Access Compliance Report Public Rights-of-Way (Curb Ramps)

Main Street: FOSTER_RD Cross Street: WALKER_LEE_DR Location: SW

ADA ID: RPRK211207124027 Ramp Type: Type 1 - Perpendicular Diagonal Initial Pass/Fail: Fail Overall Compliance: No Severity Score: 2

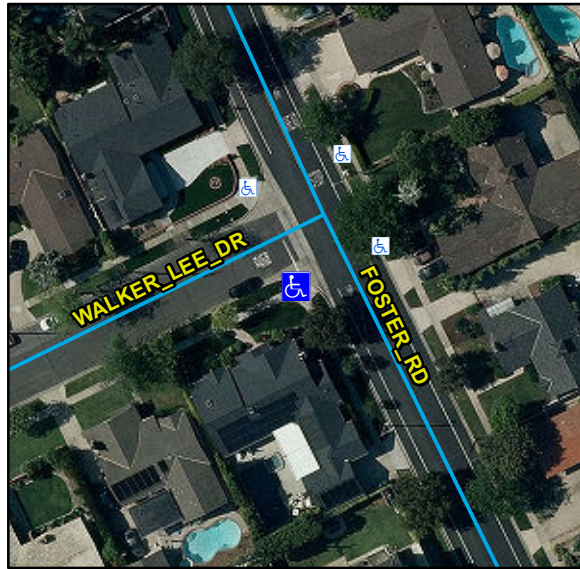
Compliance	Description	Data	Compliance	Description	Data
N/A	Ramp Length (in)	77	N/A	Flare Type LT	
Yes	Ramp Width (in)	48			N/A
Yes	Ramp Run Slope (%)	5	N/A	Flare Slope LT (%)	N/A
No	Ramp Cross Slope (%)	2.1	N/A	Flare Traversable LT	N/A
N/A	Landing Present	N/A	N/A	Flare Type RT	
N/A	Landing Length (in)	N/A			N/A
N/A	Landing Width (in)	N/A	N/A	Flare Slope RT (%)	N/A
N/A	Landing Run Slope (%)	N/A	N/A	Flare Traversable RT	N/A
N/A	Landing Cross Slope (%)	N/A	N/A	DWS Provided	N/A
N/A	Landing Movement Obstructed?	N/A	N/A	DWS Contrast	N/A
	Landing Movement Type	N/A	N/A	DWS Length (in)	N/A
N/A	Landing Shared	N/A	N/A	DWS Full Width	N/A
N/A	Clear Space	Yes	N/A	DWS Offset Left (in)	N/A
N/A	Clear Space To Crosswalk (in)	N/A	N/A	DWS Offset Right (in)	N/A
N/A	Marked Crosswalk 1	No	N/A	Marked Crosswalk 2	No
	Crossing 1 Direction	E		Crossing 2 Direction	N
	Marked Crosswalk 1 Width (in)	N/A		Marked Crosswalk 2 Width (in)	N/A

N/A	Ramp Inside Crosswalk 1	N/A	Yes	Ramp Inside Crosswalk 2	N/A
	Crossing 1 Slope (%)	7.8		Crossing 2 Slope (%)	2.8
	Crossing 1 Cross Slope (%)	1.7		Crossing 2 Cross Slope (%)	3.9
N/A	Gutter Ponding	N/A	N/A	Curb Slope	0.4
Yes	Gutter Lip Height (in)	0		Road Run Slope (%)	2.8
N/A	Gutter Run Slope (%)	N/A		Road Cross Slope (%)	1.1
N/A	Gutter Cross Slope (%)	N/A			
Yes	Overall Surface Condition: Acceptable		No	Perp Joint Present	No
	Cross Gutter Present?	Yes		Spandrel Present?	Yes
	Replace Cross Gutter?	No		Replace Spandrel?	No

Remove & Replace Curb Ramp With Two New Directional Ramps or Equivalent.

R204.3, R304.5.3, STD 1115
